Technical Advisory Group Recommendation

WORK CHANGE DIRECTIVE

TO: Hoffman & McNamara Co. PROJECT NO.: WP-42G
 PROJECT: In-Town Levees General Landscape and Plantings
 OWNER: Metro Flood Diversion Authority
 ENGINEER: Houston Moore Group
 OWNER'S REPRESENTATIVE: CH2M

Description	Budget Estimate (\$)
WP-42F.1S: Industrial Builders Inc.	
<i>2nd Street North (South of Pump Station) - Change Order #18</i>	<i>\$(147,981.32)</i>
<ul style="list-style-type: none"> • Generator connection wire quantity modification • 1st Ave N fiber optic wire and conduit addition • Unit price quantity balancing • Final Completion time extension

C-160-1

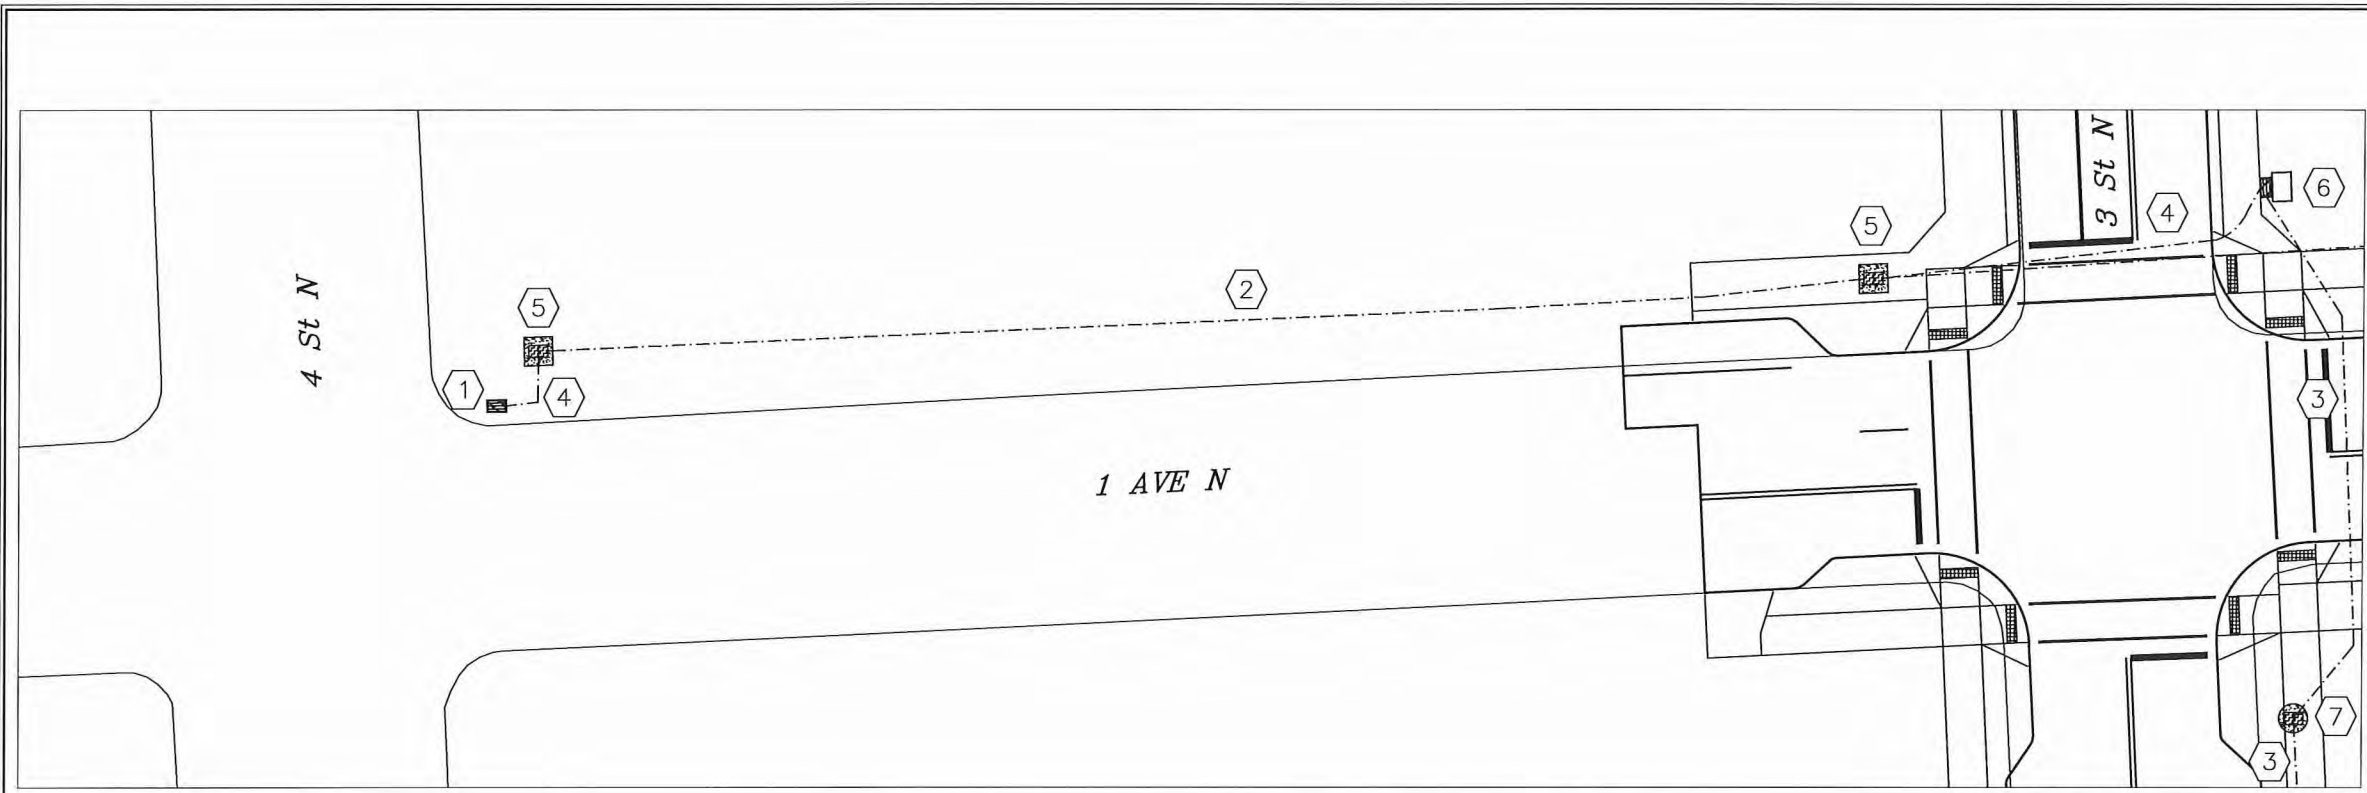
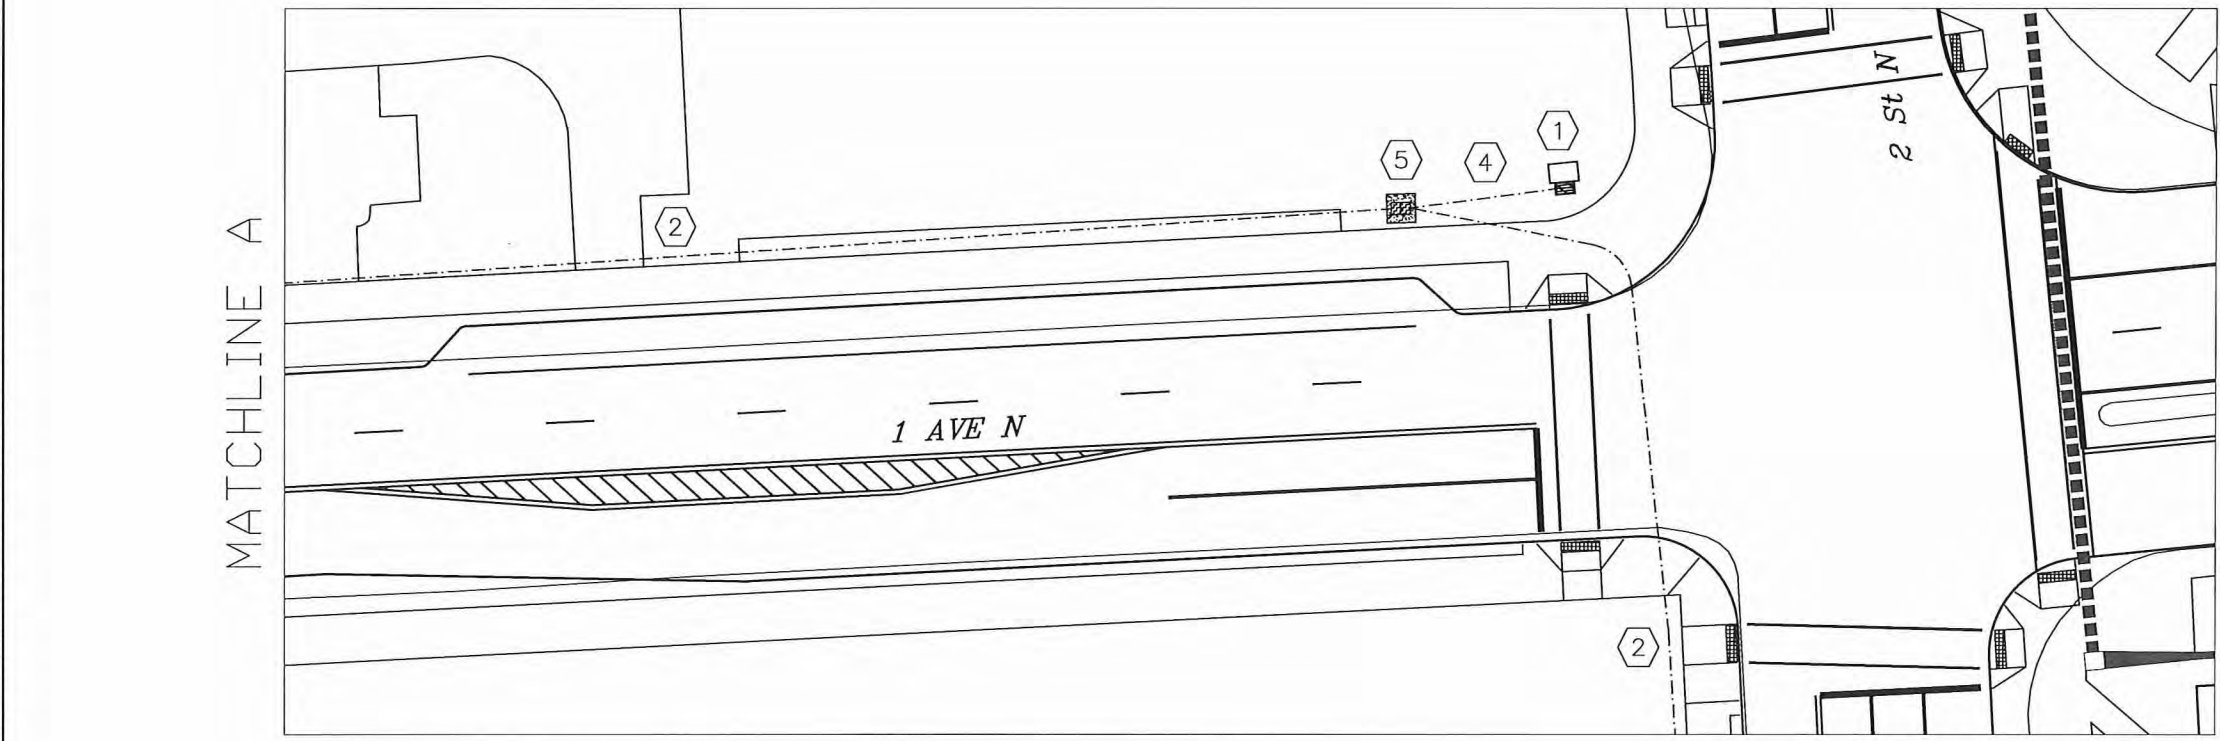
2. Add Fiber Optic Wire and Conduit: The City of Fargo requested the installation of fiber optic wire and conduit along 1st Ave. N between 2nd St. N and 4th St. N.

2. 1st Avenue North Fiber Optic Wire and Conduit
 - a. Add lump sum bid item *0267 1st Avenue North Fiber Optic Wire and Conduit* for \$46,488.20 to accommodate the installation of fiber optic wire and conduit around the project site for traffic signals as requested by the City of Fargo along 1st Avenue North between 2nd Street North and 4th Street North. The attached Change Order Unit Price Schedule dated 10/13/2017 shows the additional bid item. The attached Change Order Plan Sheets dated 9/13/2017 shows the fiber optic wire and conduit to be installed. There is a schedule change with an increase of 17 calendar days associated with this change item.

- This change order provides the deduction option for the 5th line wires which will not be installed but the conduit will still be placed between the pump station and the generator. The second item is an owner request to install fiber around 1st Ave N based on plan sheets dated 7-31-17 from HMG.

- a. ADD Bid Item 0267, 1st Avenue North Fiber Optic Wire and Conduit: Add the quantity 1 LS at the Contract Unit Price of \$46,488.20 for a price increase of \$46,488.20.

Change Order No. 01

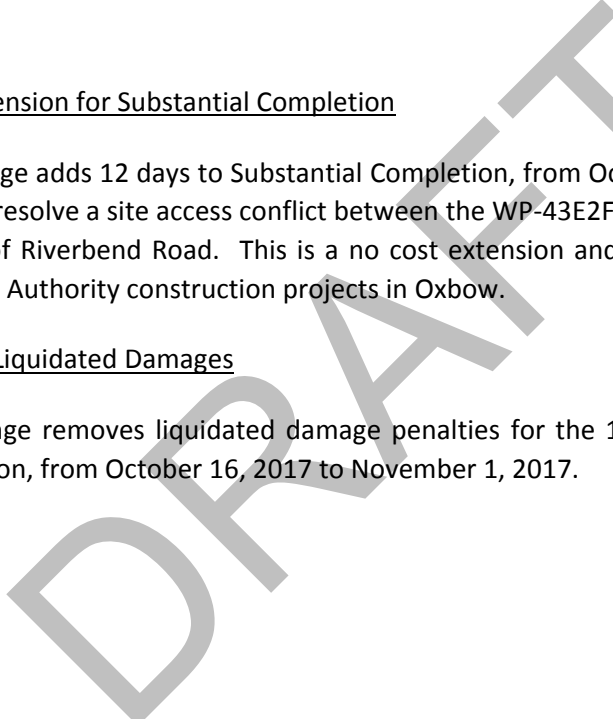
1. Time Extension for Substantial Completion

This change adds 12 days to Substantial Completion, from October 16, 2017 to November 1, 2017, to resolve a site access conflict between the WP-43E2F and WP-43CD contractors for a portion of Riverbend Road. This is a no cost extension and it will not it impact any other Diversion Authority construction projects in Oxbow.

1. Construct a 20-ft. wide, 8-inch deep aggregate road from the new Riverbend Road to the east on the north side of the existing drainage ditch as shown in yellow highlighting on the attached drawing. This section of gravel would provide Landwehr Construction access to the project site.

2. Provide a 60-ft. wide access area with a 20 ft. wide, 8-inch deep aggregate road from the north side of the old 816 Riverbend Road driveway to the south end near the existing drainage ditch as shown in yellow highlighting on the attached drawing. Additionally, the Diversion Authority would extend the culvert to the east in the existing drainage ditch in order to for Landwehr to adequately cross the existing drainage ditch and remove the last of the structures and complete their contractual requirements. As shown on the map, the proposed stock pile of clay material will not be placed in the 60-ft access area nor the 20-ft road area.
